Re: Agnico Eagle Mines – Meadowbank Division Responses to Freshwater Intake Station Design Report Comments

- CIRNAC – August 17, 2018, *Crown-Indigenous Relations and Northern Affairs Canada (CIRNAC) Technical Review Comments of the Design Report Fresh Water Intake –Whale Tail Project under Agnico Eagle Mines Limited's Type "A" Water Licence No. 2AM-WTP1826.*
- DFO - August 16, 2018, *Submit comments for project 2AM-WTP1826 for Agnico Eagle Mines Ltd.'s Design Report Fresh Water Intake*

G:\PROJECTS\PT- PROJETIS 2017\PT 1704282 - Agence-Erable-Amarek - Fresh water pumping station\DESSINS-EN PROGRES\BOITE À DOISSONS-MISES EN PLAN\PT 1704282-0001.dwg

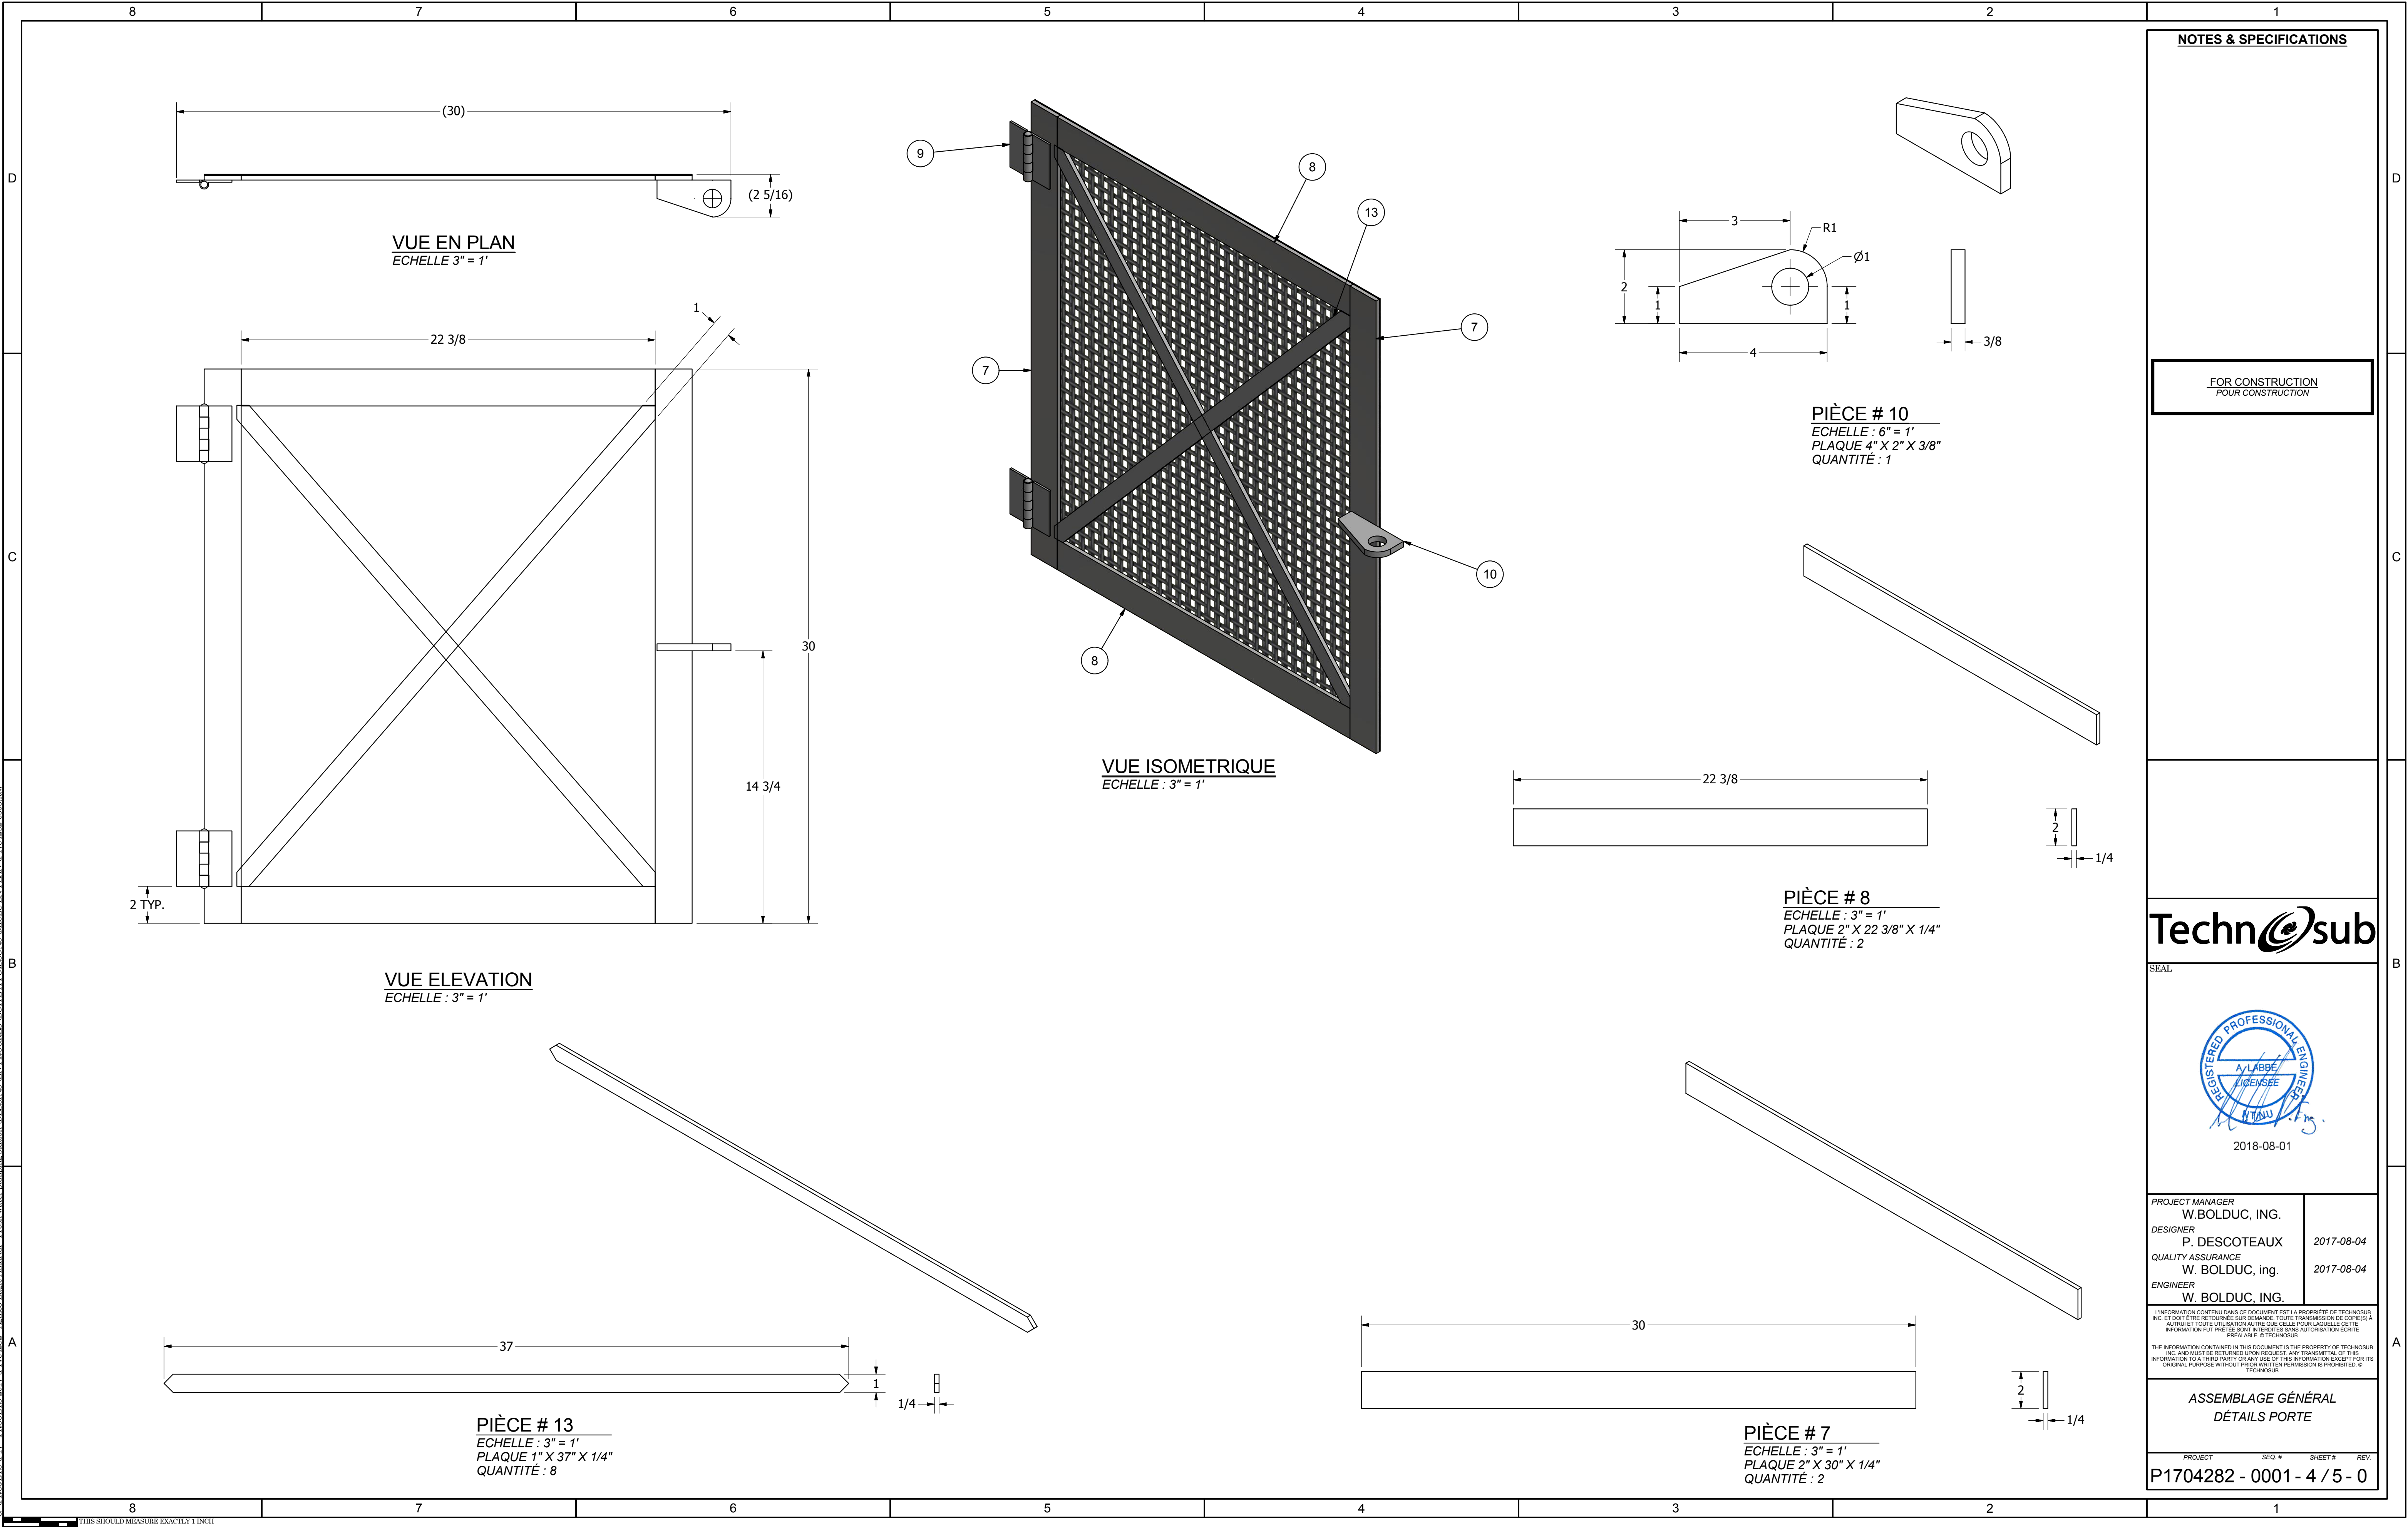
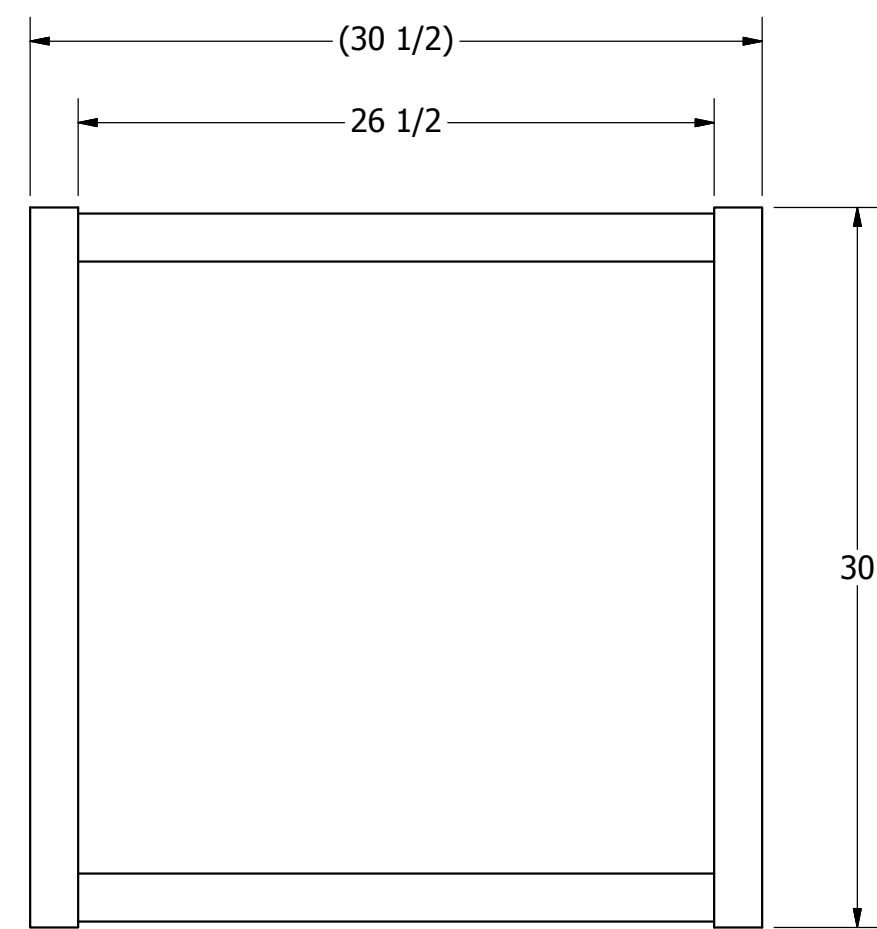
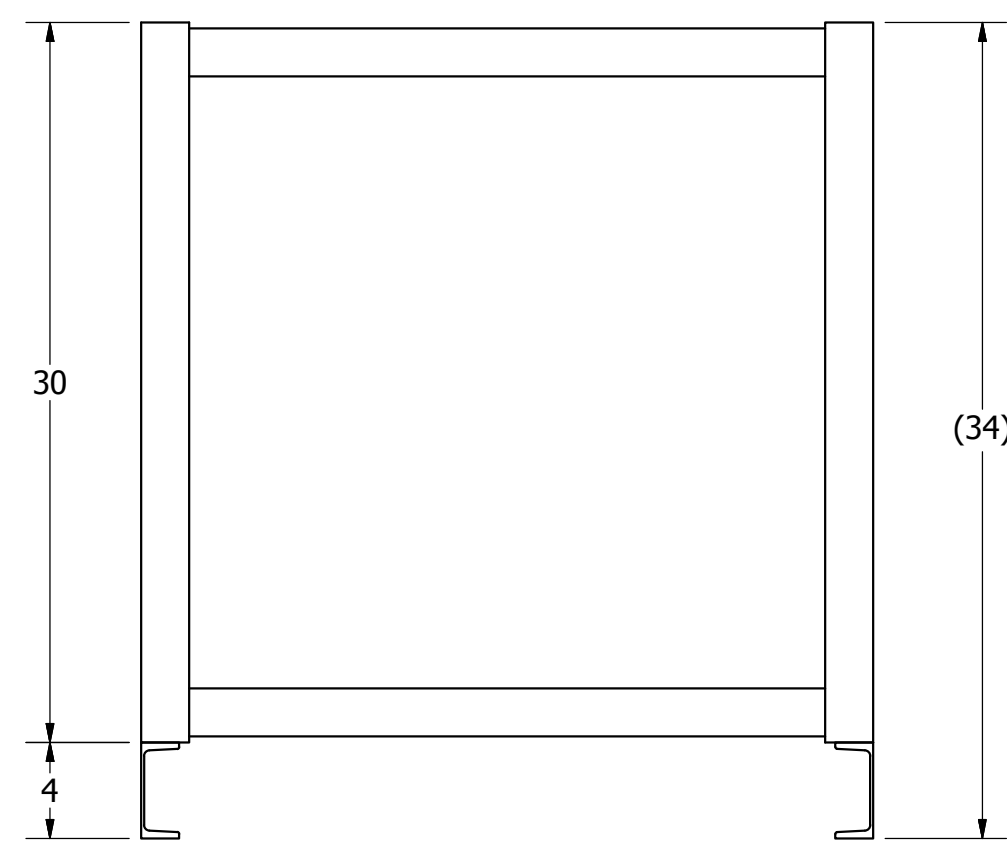
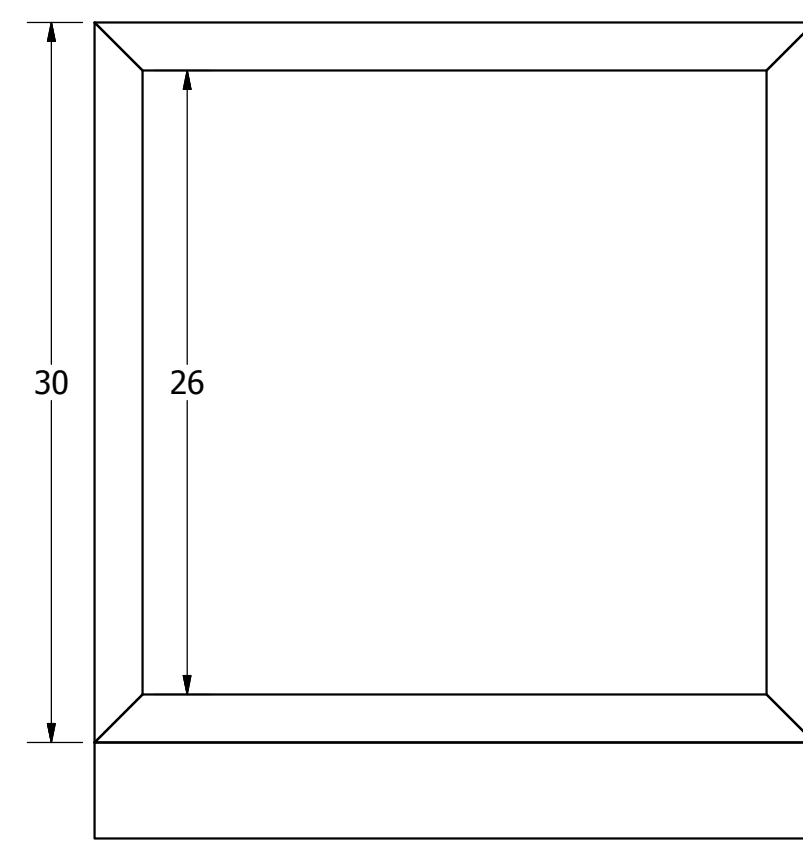
CIRNAC requests confirmation that the screen mesh size used also complies with the Department of Fisheries and Oceans fish screen guidelines.

Comment: DFO-FPP acknowledges that AEM has committed to using fish screens on intakes in an effort to avoid the entrainment and impingement of fishes. However, DFO-FPP is unclear what calculations/ data/ information (i.e., species swim speeds, water intake velocities) were used to determine the appropriate size of screens that were proposed by AEM to avoid the entrainment and impingement of the fish at the intakes and on the screens.

The pumping box has been designed in accordance with DFO's Freshwater Intake End-of-Pipe Fish Screen Guideline. The mesh size selected is ½" (see Figure 3). The design was performed for the anguilliform swimming mode.

The mesh size selected, ½" (see Figure 3), will ensure fish are not entrained. Based on the Freshwater Intake End-of-Pipe Fish Screen Guideline, the area required for anguilliform mode for 550 USGPM is 9.8 ft². For ½" mesh opening, the opening % is 57 %. The required area of sieve is thus 17.2 ft². The suction box is designed for 23.9 ft² sieve area. This will ensure fish are not impinged on the screen/suction box. Detailed engineering of the suction box can be found enclosed with this letter and in Figure 3.
